SUBJECT: ADDENDUM No. 1

FILE: FHWTP Flocculation and Sedimentation Basins 1 & 8 Equipment Upgrade WT7093

**FLEMING HILL WATER TREATMENT PLANT FLOCCULATION AND
 SEDIMENTATION BASINS 1 & 8 EQUIPMENT UPGRADE PROJECT – WT7093**

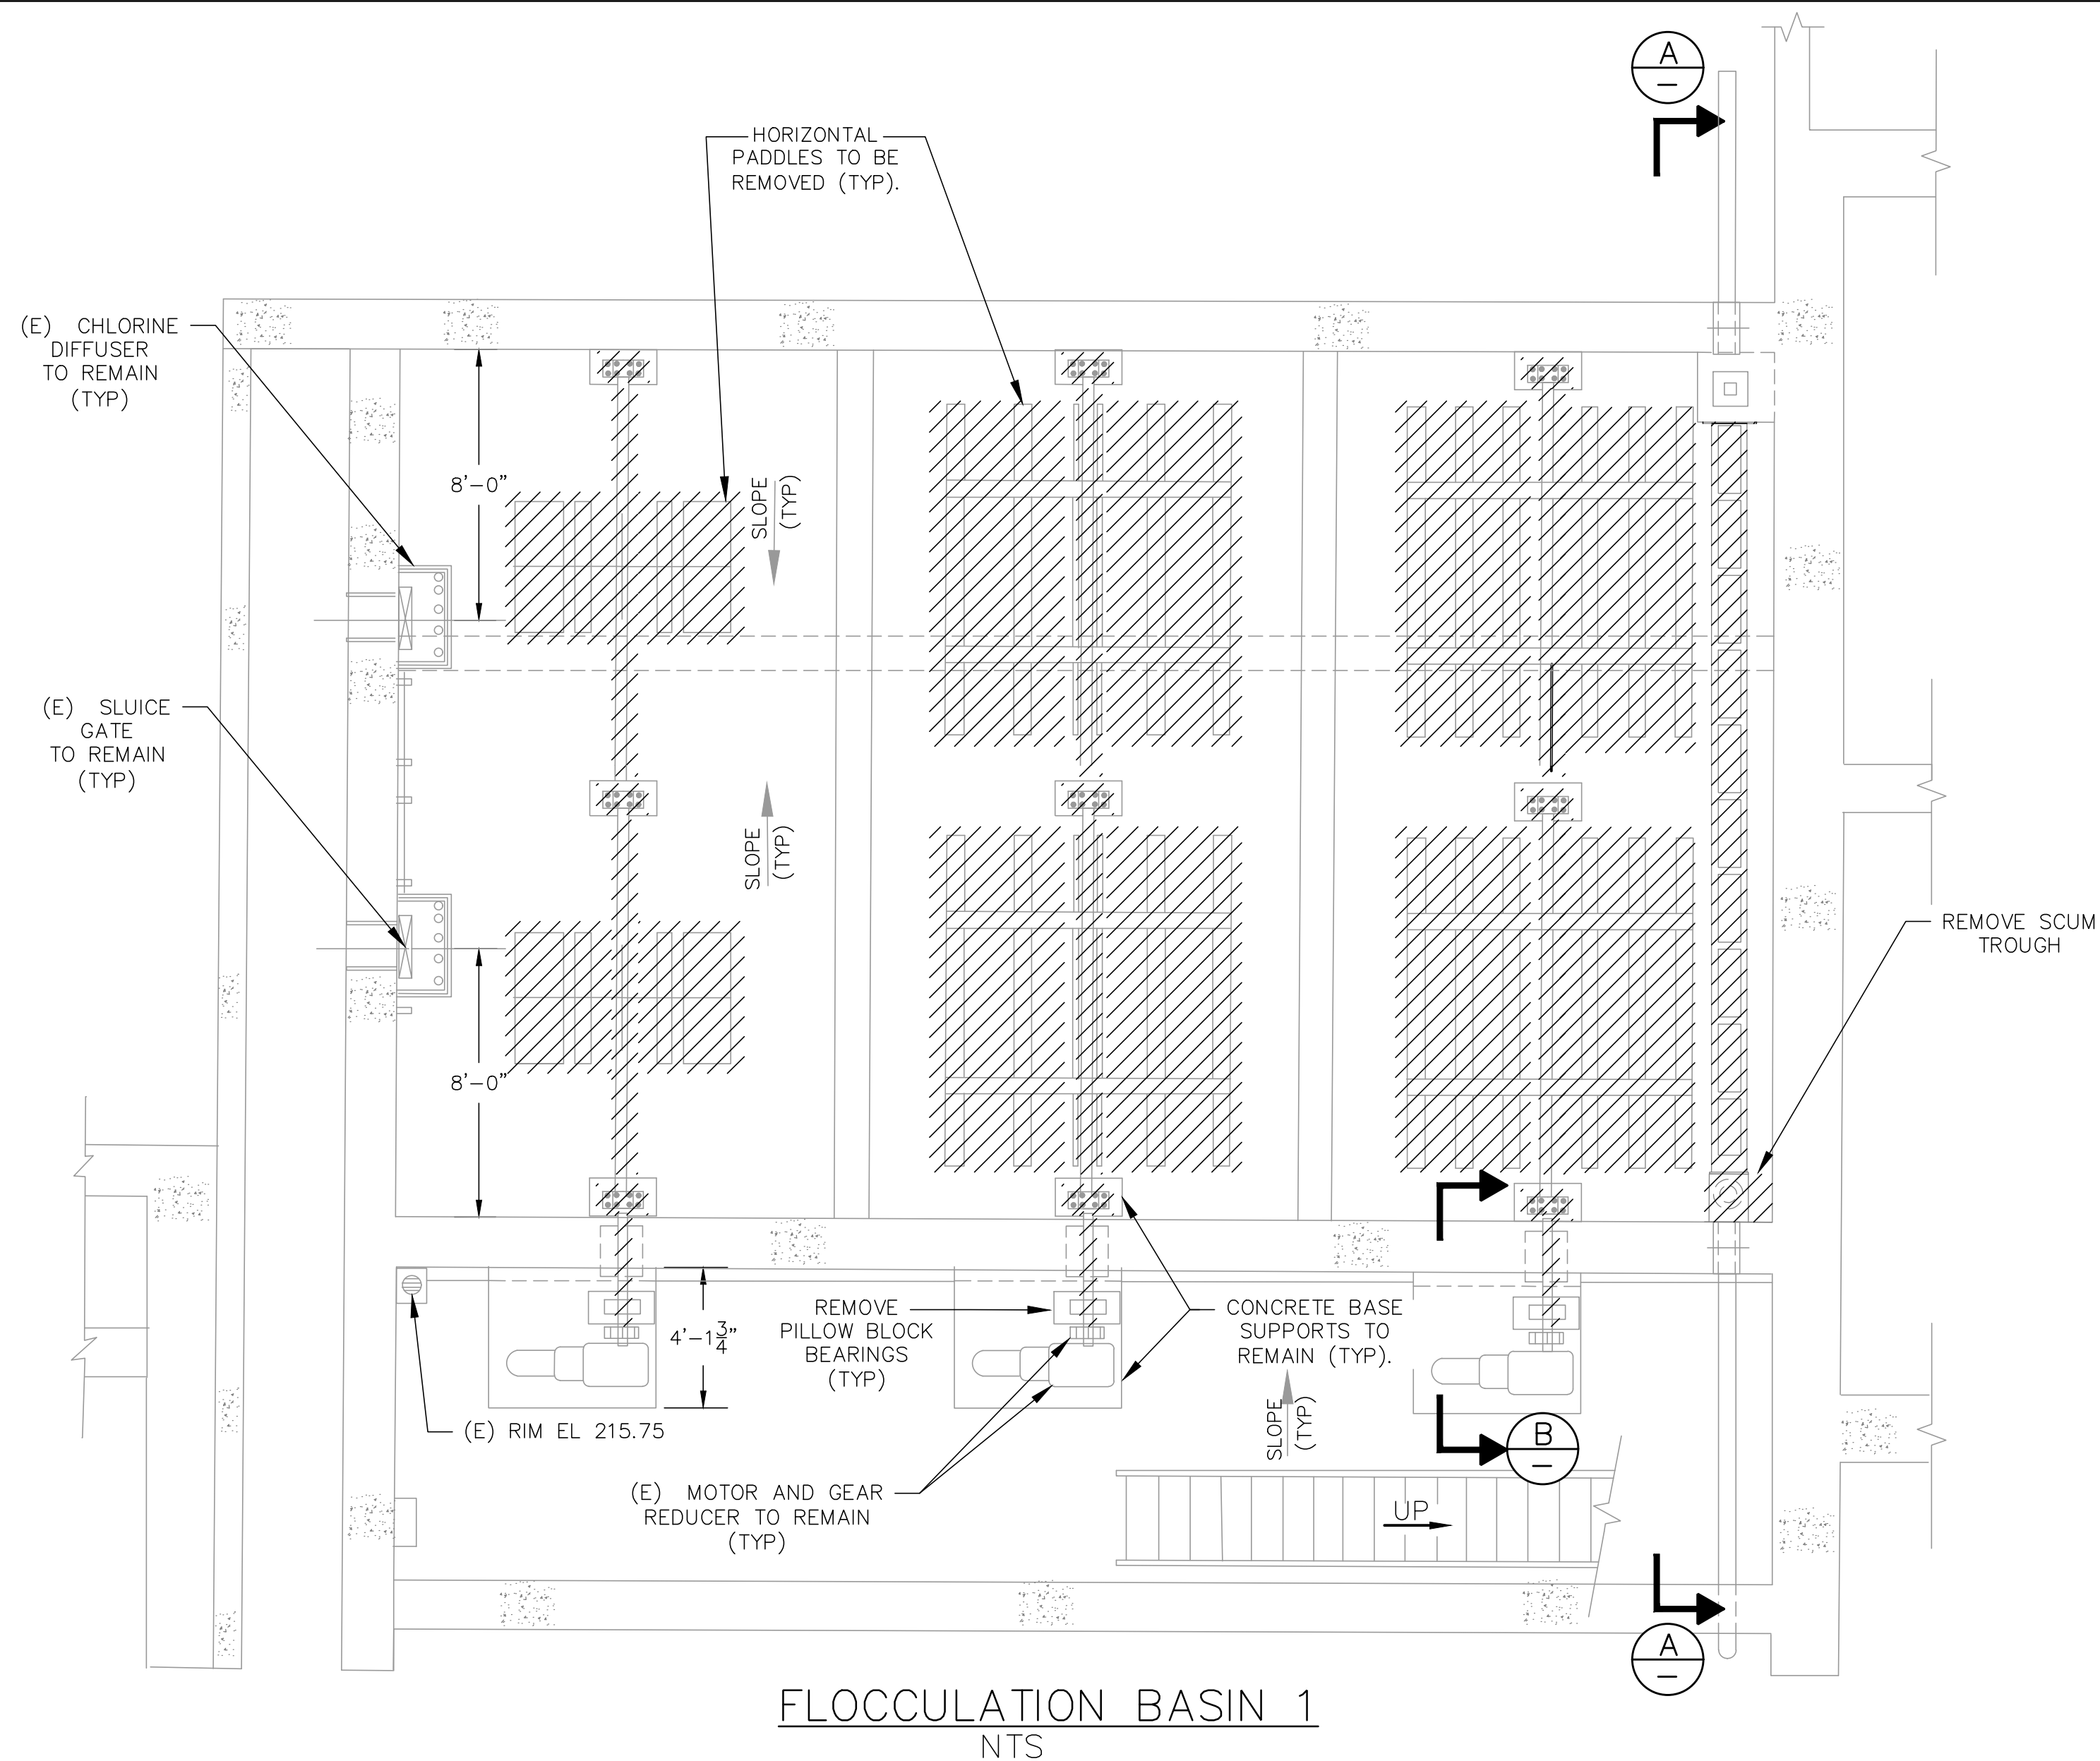
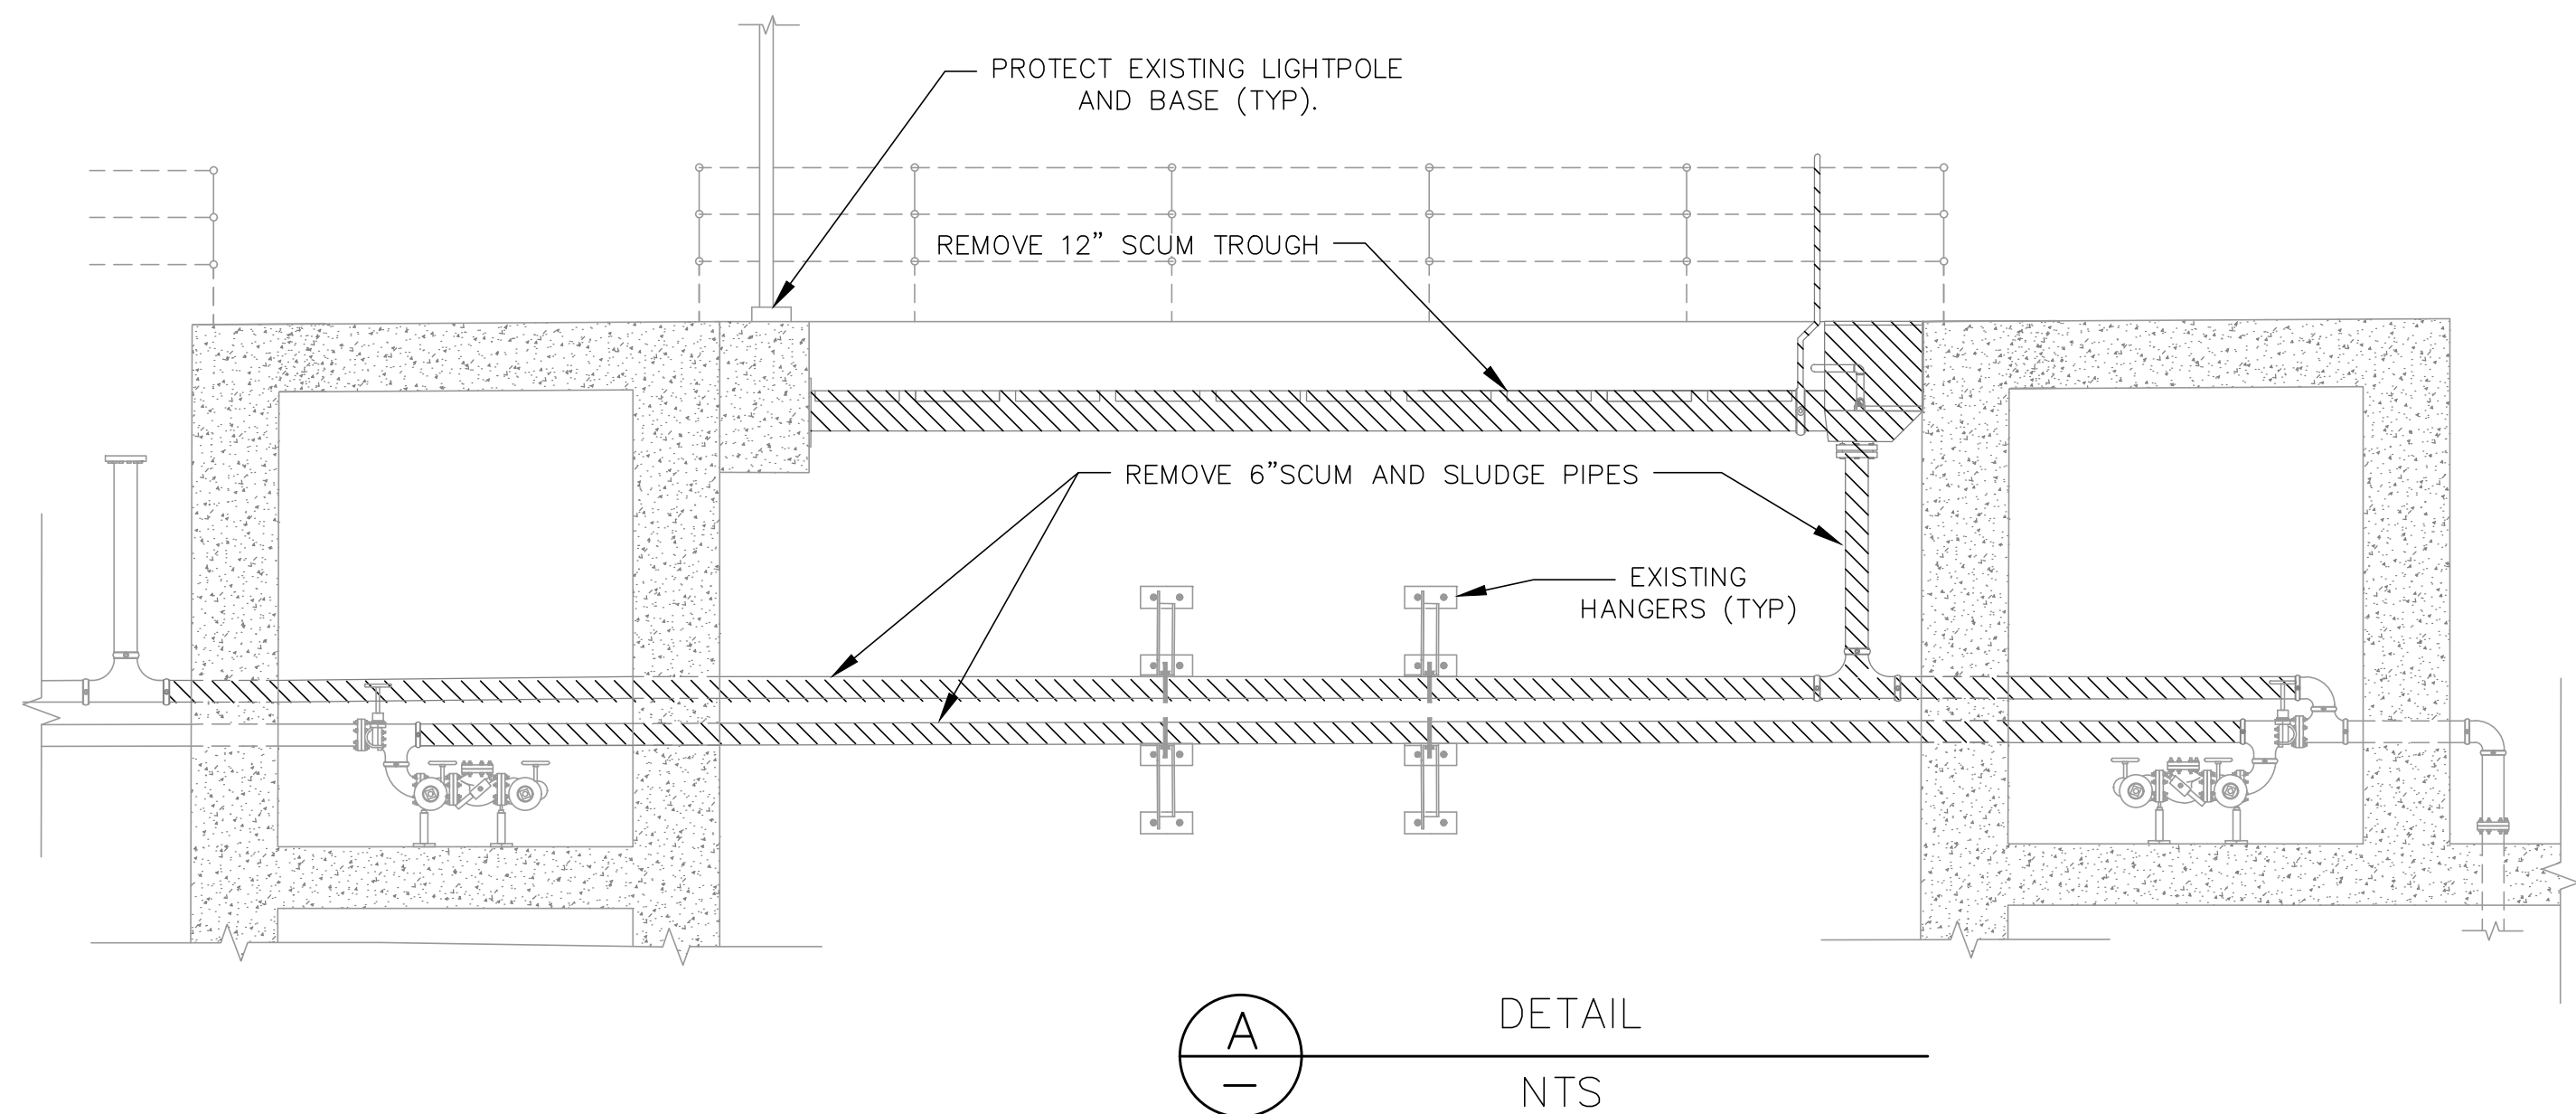
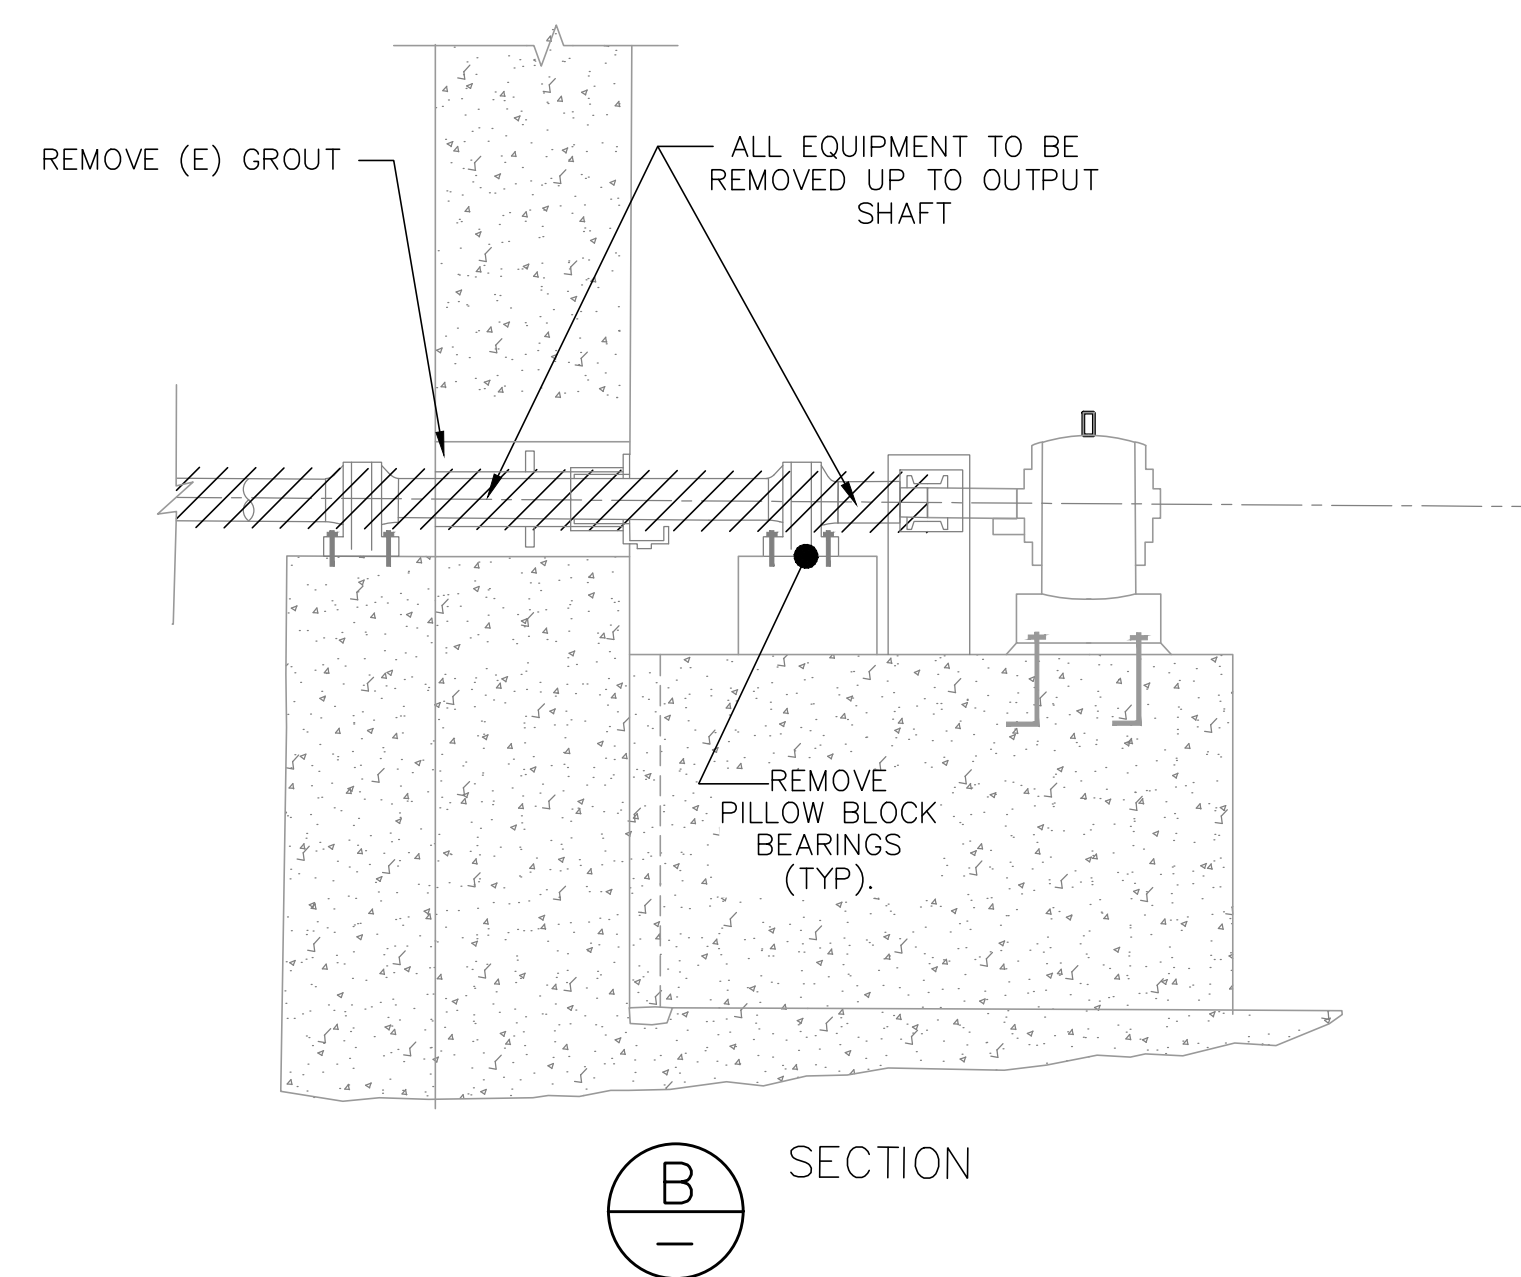
Sheet 5: Revised Notes. Moved Chain and Flight Details to Sheet 7.
